project title
Retail Pad Building
 Northwest Corner of Paseo Del Norte and Golf Course Road
 Albuquerque, New Mexico
 sheet title
Site Development Plan for Building Permit

EFC COMMENTS

project title Retail Pad Building
Northwest Corner of Paseo Del Norte and Golf Course Road
Albuquerque, New Mexico
sheet title Landscape Plan

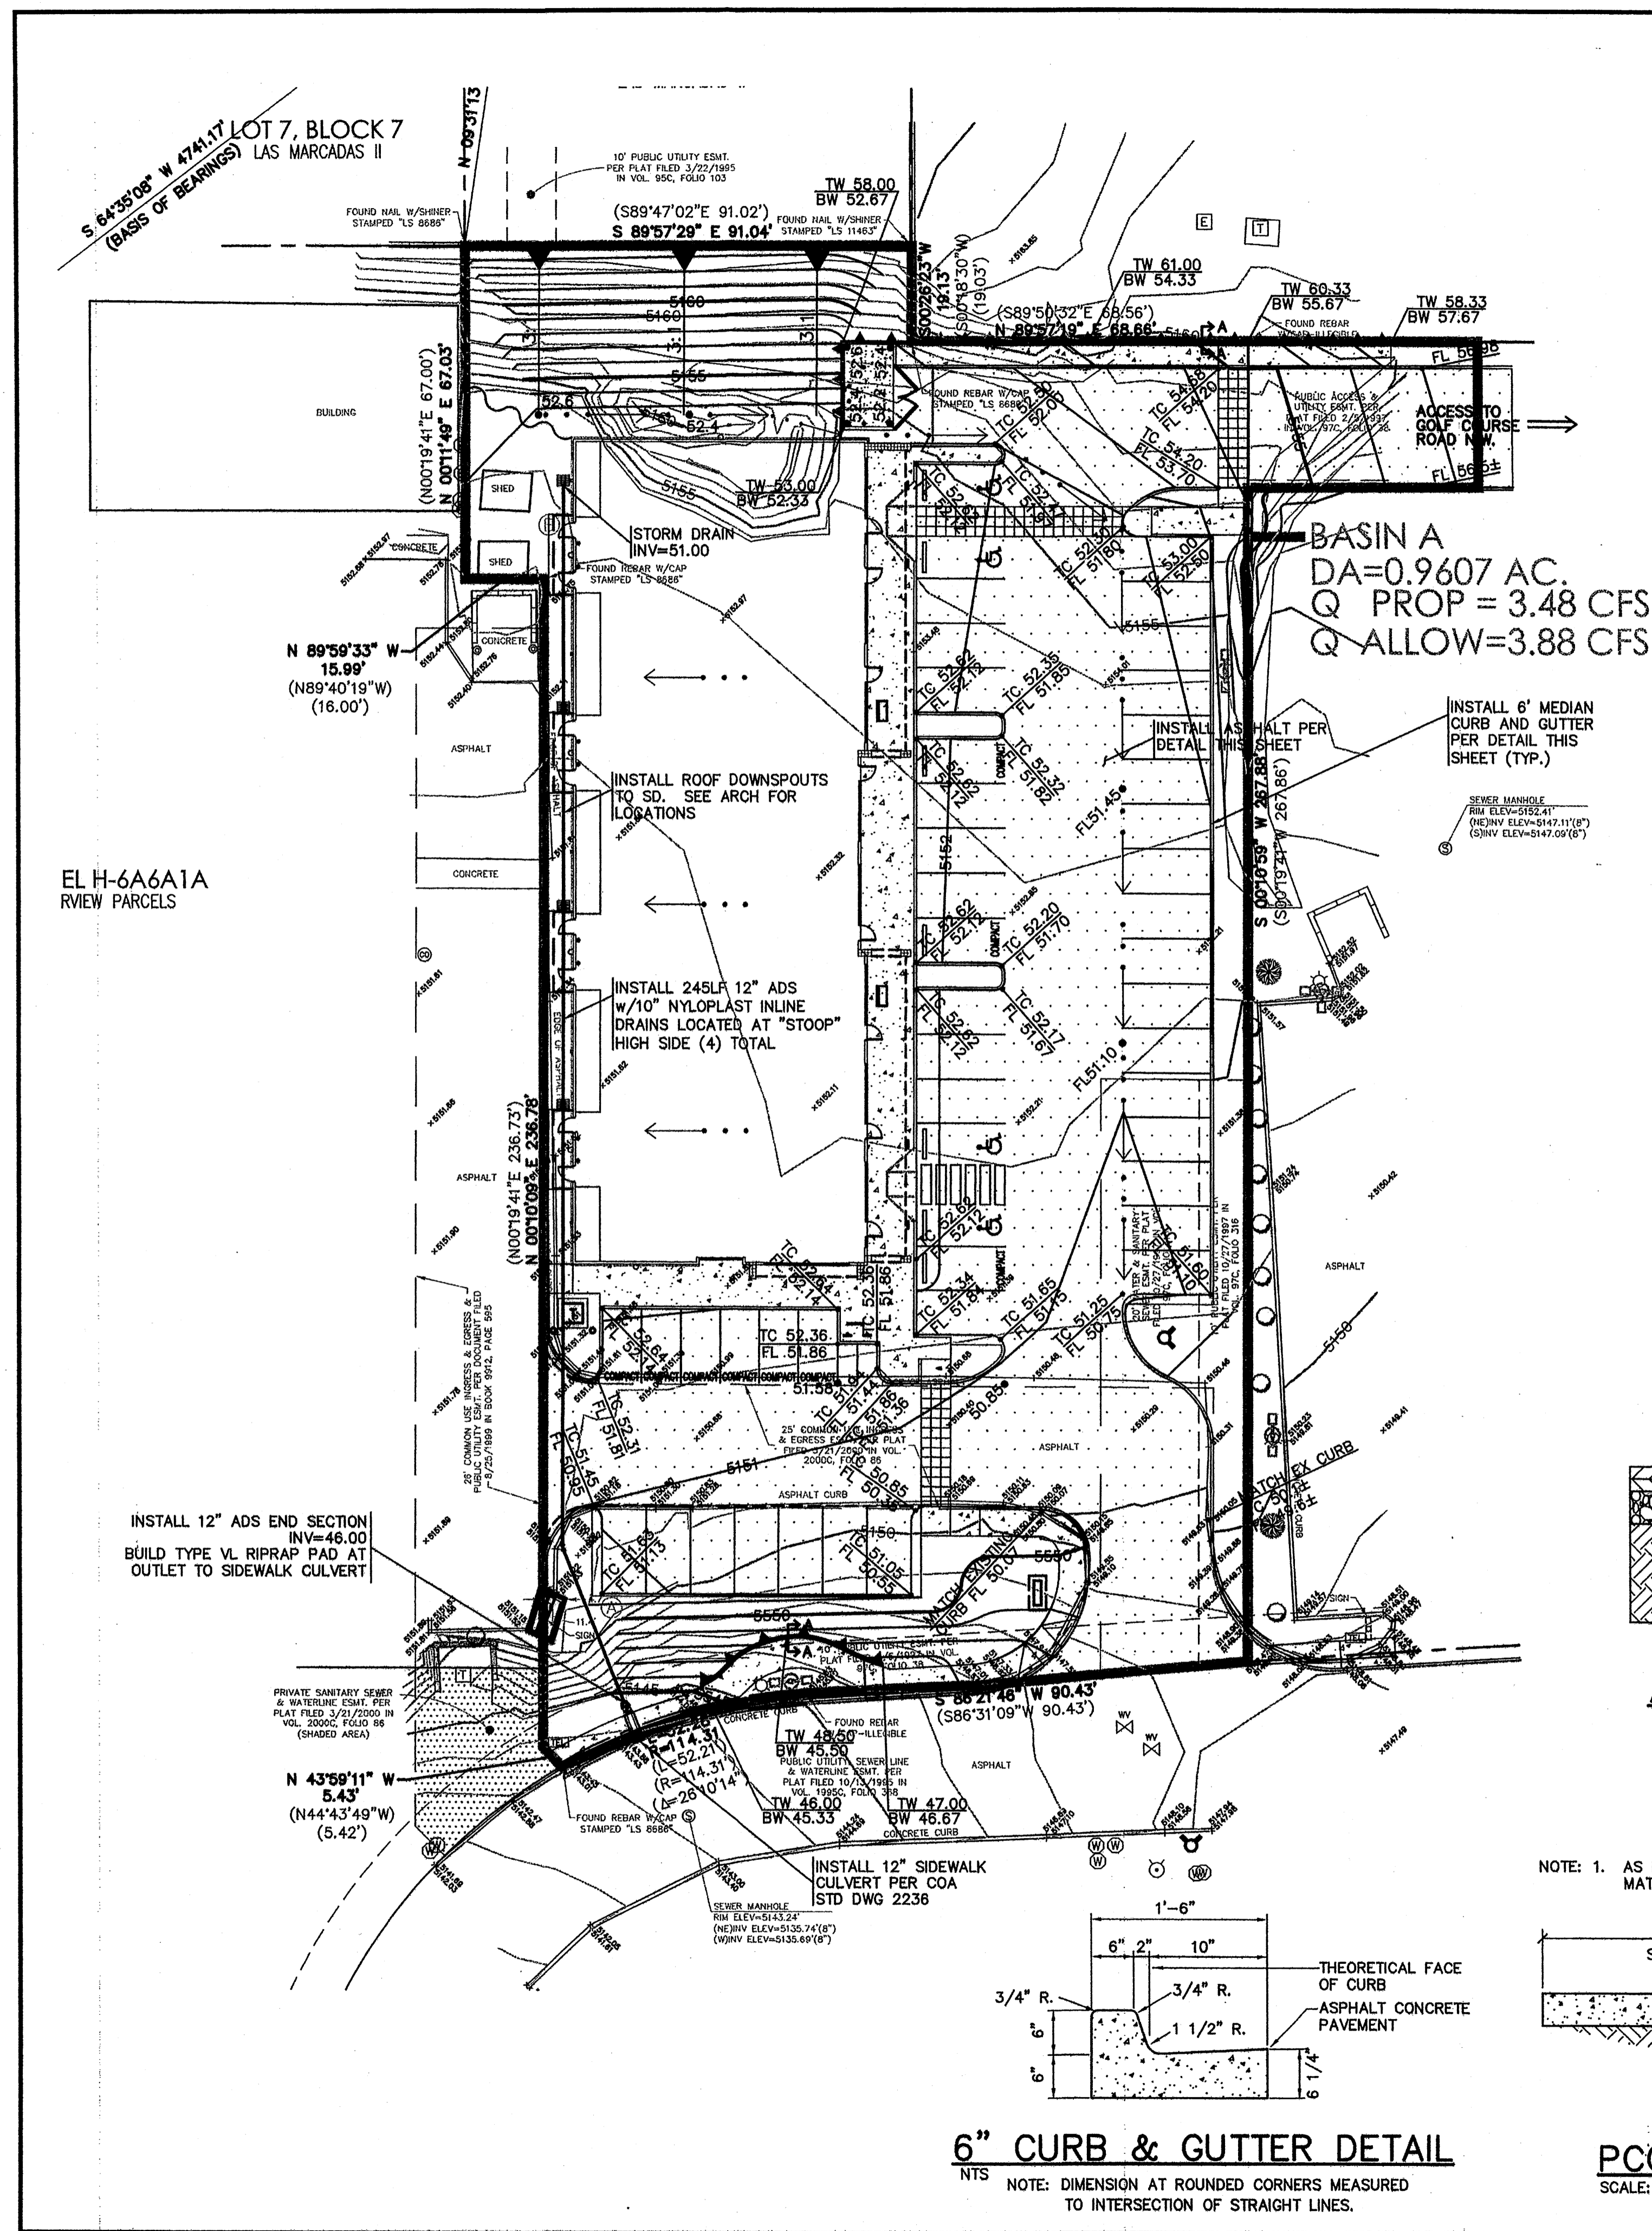
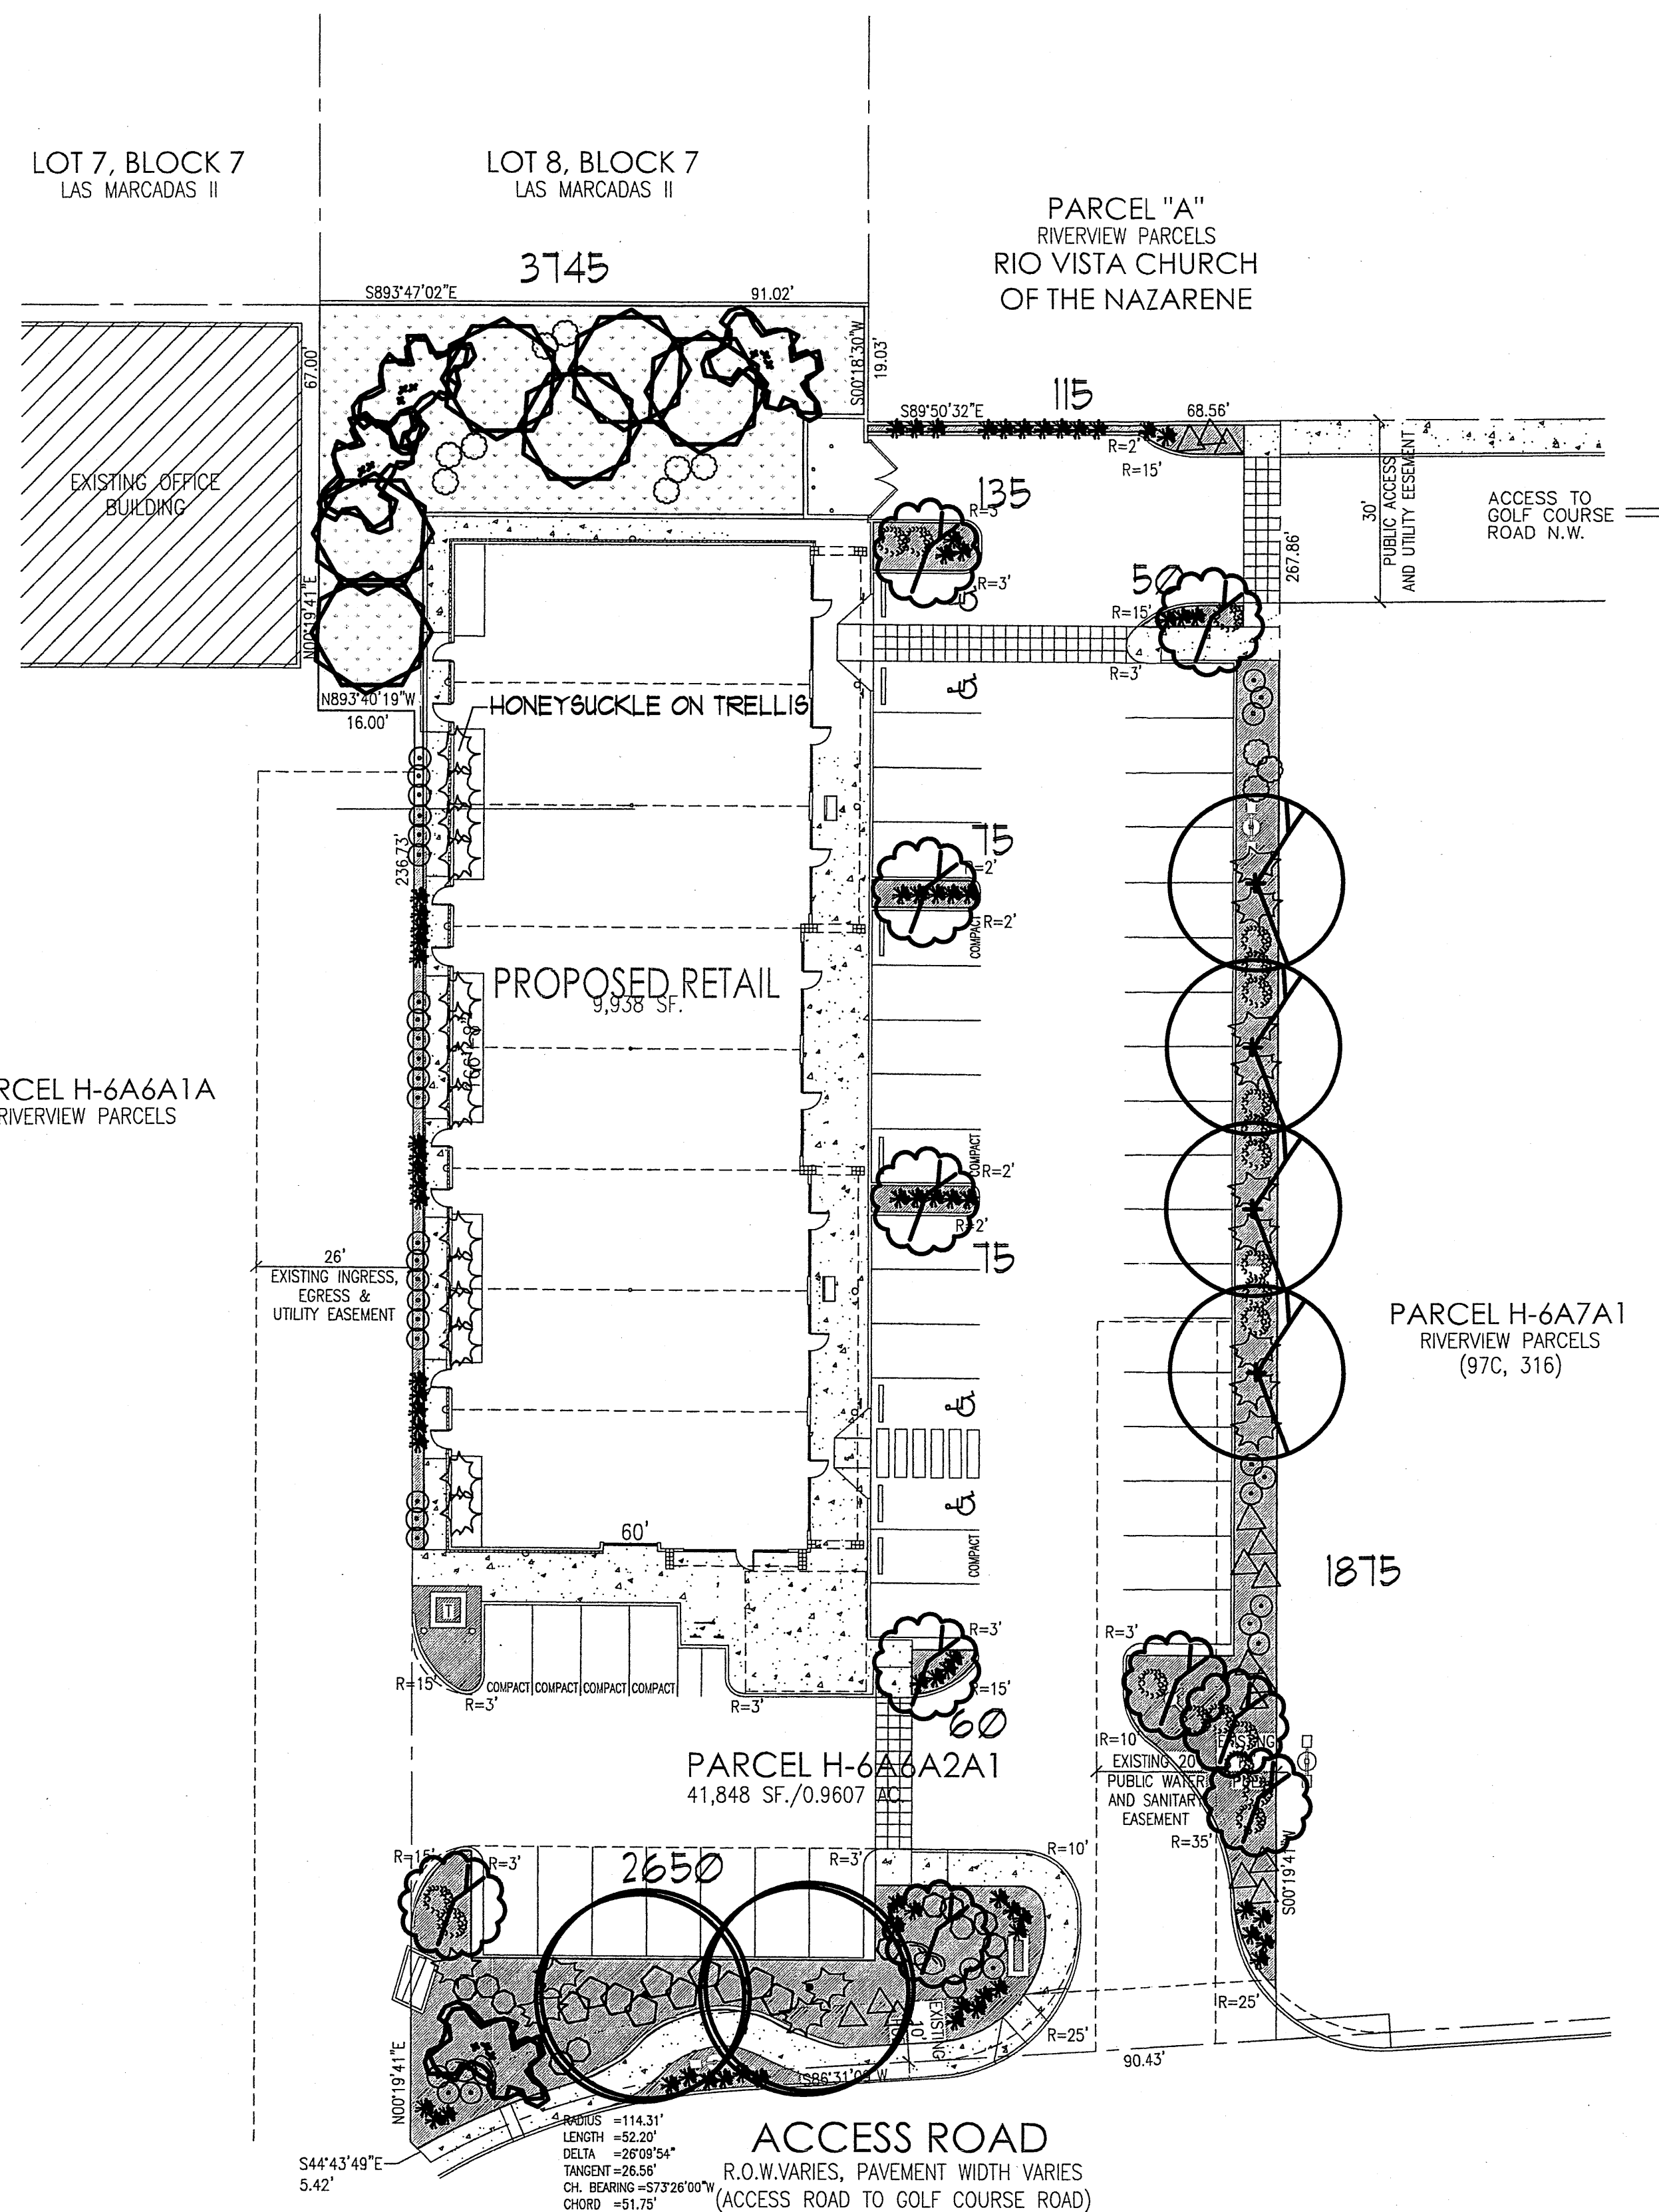
The landscape plan shall be revised as follows:

Replace a majority of the medium water use with low water use, preferably, native plants to further the city's water conservation and sector area policies.

All trees need to be 2" caliper or 10-12ft, minimum (zoning code section 14-16-3-10(F))

Replace the Austrain pines, which grow to 35', with Pinon Pine which will have less impact on the views to and from the escarpment and views from adjoining residential properties.

The irrigation note needs to specify a minimum of 5 one g.p.h. bubblers or "metafim spiral" system or equal per tree, per the City Forester.

The live ground cover shall be a minimum 80% coverage at maturity, excluding tree canopy.

The south bed require adjustments to accommodate the retaining wall (currently missing) and, possibly, to ensure that the monument sign of the adjacent office development is not obstructed.

The west side trellises shall be planted with Honeysuckle.

Landscape shall be watered by a complete underground irrigation system operated by automatic timer. Trees shall have (5) 1/2" bubblers and shrubs shall have a minimum of (2) 1/2" emitters per shrub, PER THE CITY FORESTER, (SEE EFC COMMENTS)
